EASTERN ROUNDABOUT PLAN

Client: Northvale County Council
Designer: Arden Moss Consulting Engineers
Kestrel Valley Link Road
Eastern Roundabout General Arrangement
Drawing number: KVL-ADM-510-DR-C-0501
Revision: C02 Status: FC - For construction
Scale: 1:250 @ A1 Date: 12 August 2025
Drawn: NH Checked: DO Approved: PN

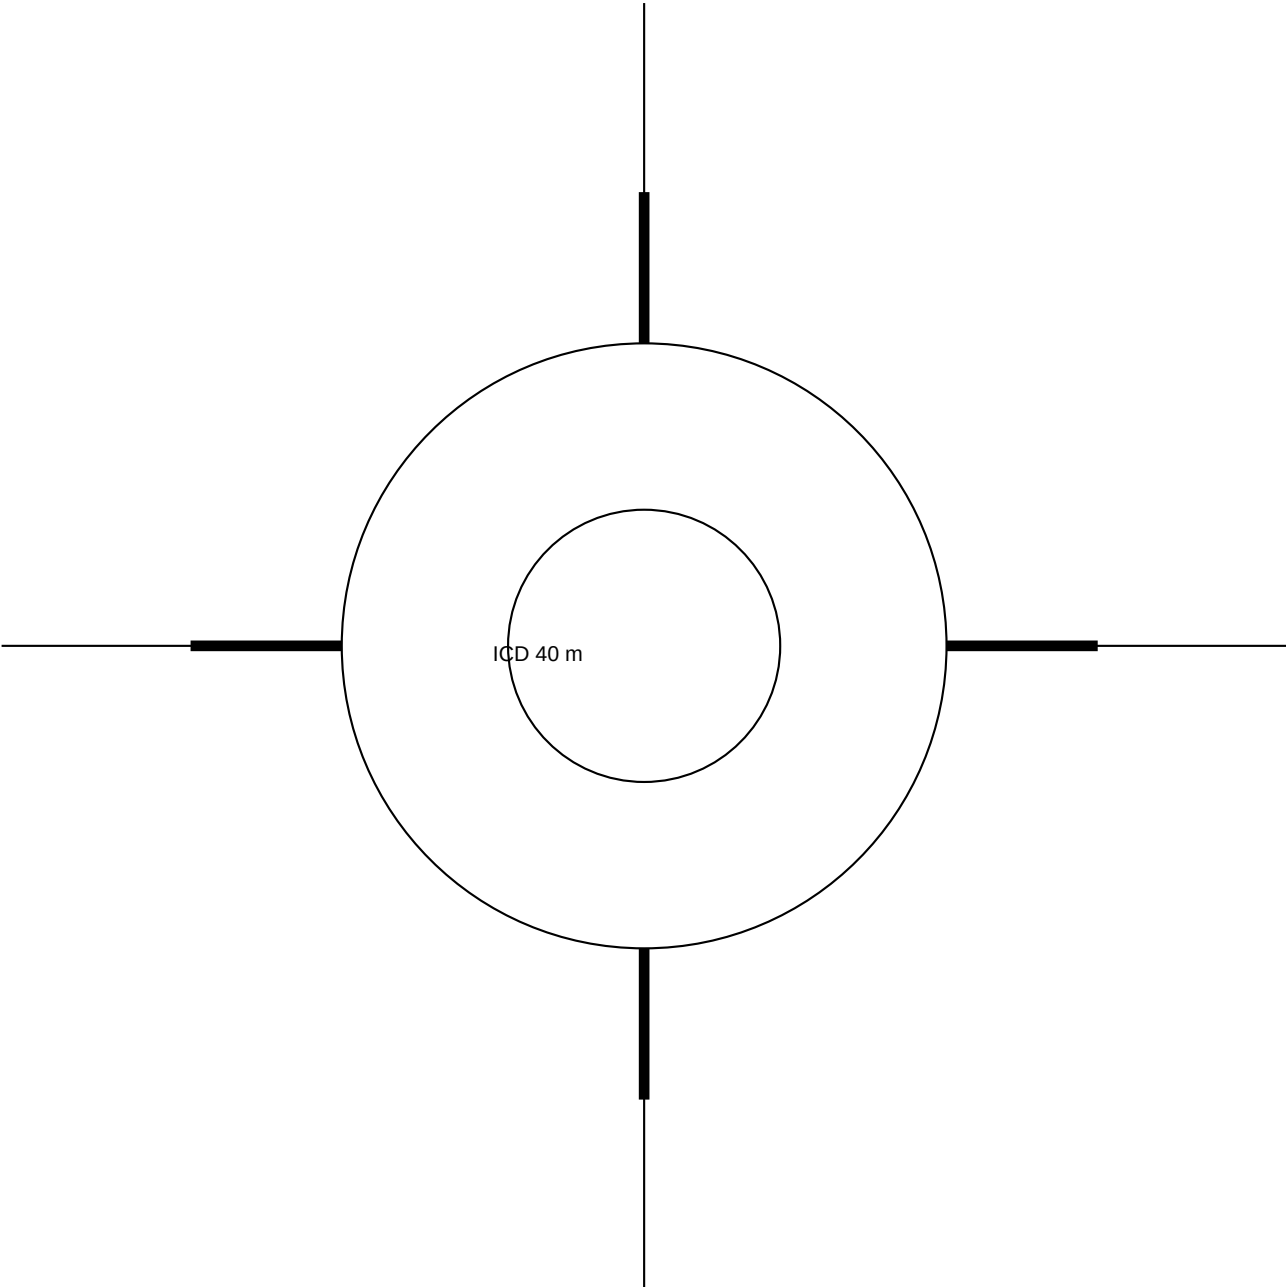
Rev	Date	Description
C02	12/08/2025	High friction surfacing added on approaches
C01	12/03/2025	Issued for construction

Heavy line: high friction surfacing, final 50 m of each approach

- 1. Circulatory carriageway surface course SMA 10 with PSV 65 aggregate (alternative accepted).
- 2. High friction surfacing on the final 50 m of each approach. See KVL-ADM-510-LT-C-0036.
